**Technology Inclusive Risk Informed Change Evaluation (TIRICE)  
For Non-Light Water Reactors**

**Change Control Scope and Process  
For a Reactor Licensed in Accordance with the NEI 18-04 Guidance**

Document Number  
SC-16166-107  
Revision ~~BD~~

Issued for Collaborative Review by:

**Figure 1. 10 CFR 50.59 Process for a Reactor with an LMP-based Affirmative Safety Case**

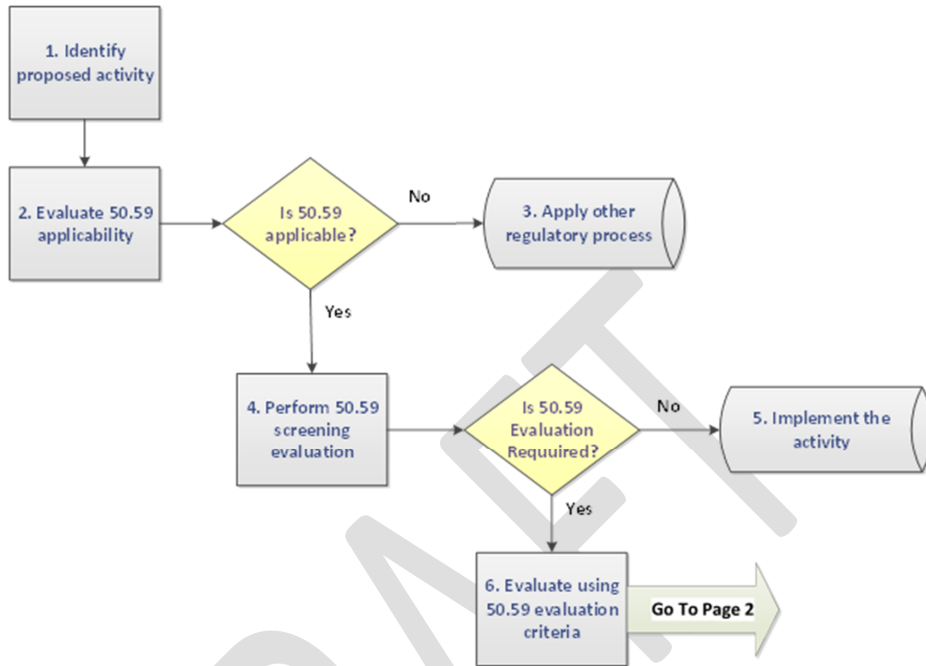
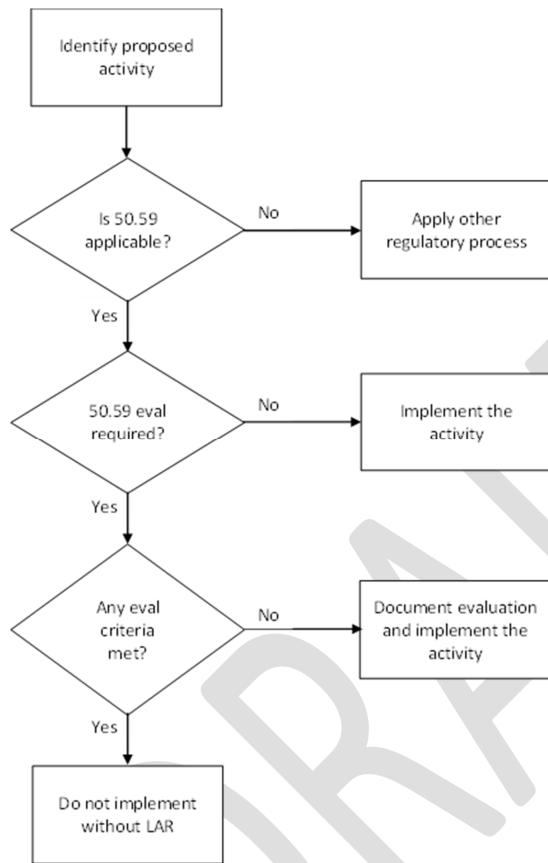
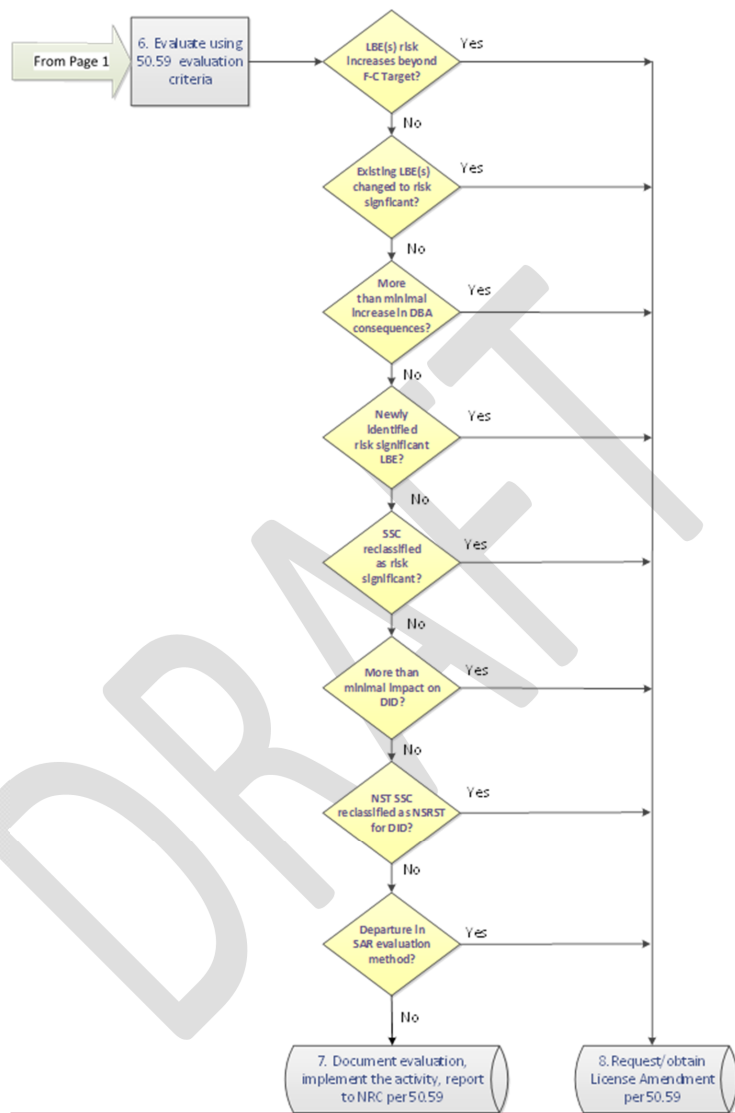
**Commented [A40]:** As commented earlier, this section doesn't discuss first performing the technical evaluation of a proposed change to see its effect on the LMP safety case

**Commented [A41]:** This section and its associated Figure 1 are confusing regarding the depiction of similarities and differences from 50.59. The figure seems to highlight two key aspects from the 50.59 process (applicability, evaluation required) for comparison, but then the text in 3.1, 3.2, and 3.3 addresses three topics (applicability, screening, evaluation).
